**CITY OF CARPINTERIA
ARCHITECTURAL REVIEW BOARD
Meeting of April 16, 2015**

Agenda Item #D-3

**COMMUNITY DEVELOPMENT DEPARTMENT
PROJECT REVIEW**

Project: 14-1738-ARB **Planner:** Nick Bobroff
Address: 5566 Retorno Drive
APN: 003-340-015
Zoning: Single Family Residential (6-R-1)
Applicant: Dylan Chappell Architects for Susan and Bruce Bornhurst

(P) ELEVATIONS W - S

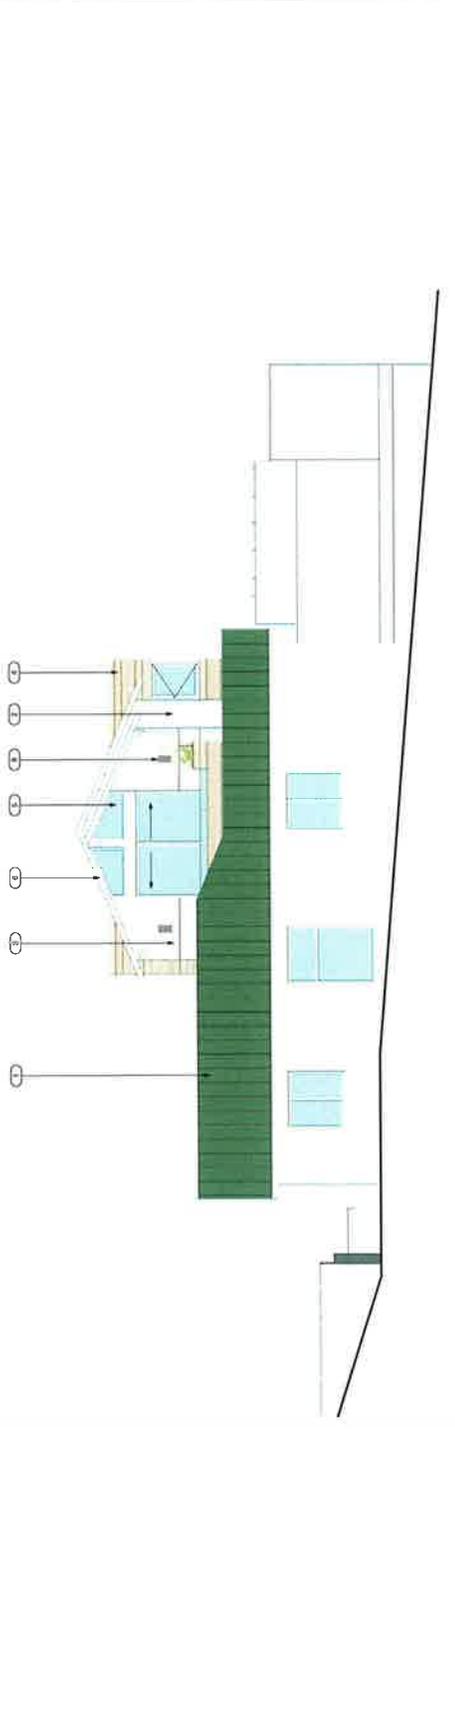
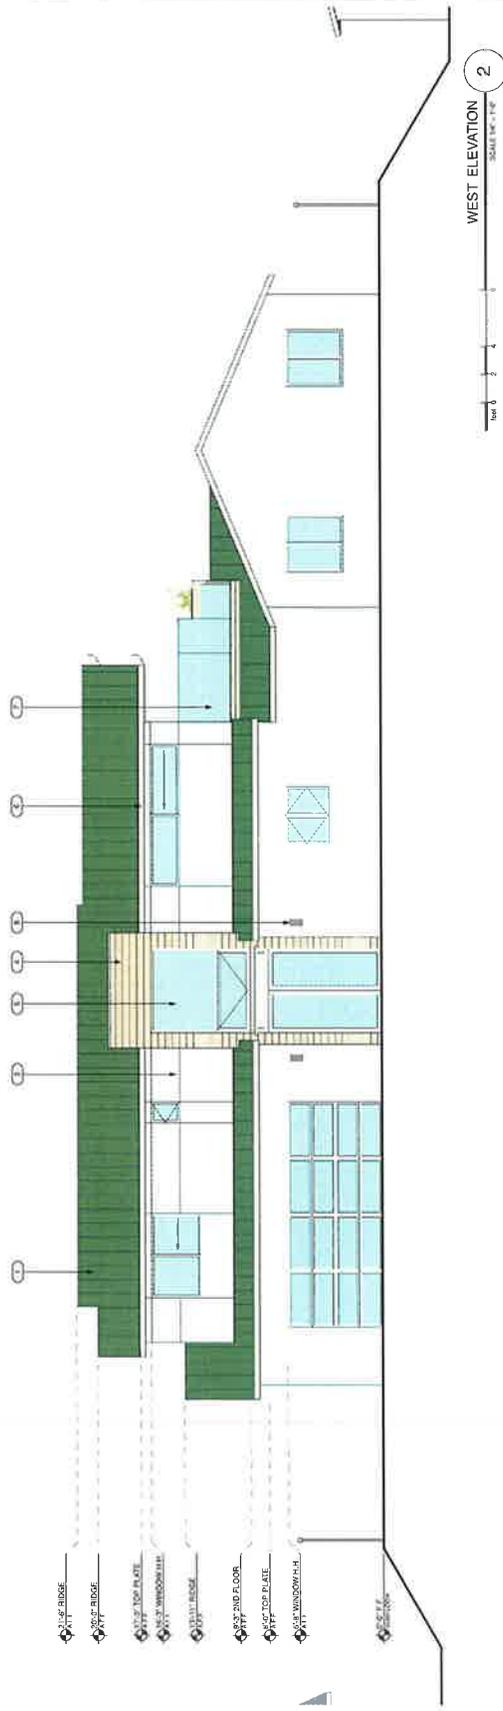
A more detailed set of working drawings have been prepared for the Final ARB submittal. These include more fully dimensioned plans, architectural details, electrical plans and structural plans. Exterior colors/materials are specified on the elevation sheets (A3.1/3.2); a color/material board will also be available at the meeting for the Board's review.

Several revisions have been made to the project since the Board's last preliminary review. Per the Board's recommendation, where possible, second floor window sills have been raised to five feet. The rear railing of the deck has also been raised to five feet in height; a small planter has been added at the rear corner of the deck rail as a transitional element to step the railing height down to the deck side/front. Deck railing materials were updated to use a combination of ship lapped siding (matching that used on the entry element) and frosted glass.

After exploring various options for the entry element, the applicant opted to return to the original flat roof design (as opposed to the gable previously shown). However, the window layout for the entry element has been simplified and a lighter colored ship lapped cedar siding (treated with Cabot's bleaching oil) has been selected. The other areas of the house using the ship lapped siding (i.e., rear popout and second floor deck) would receive the same bleaching treatment.
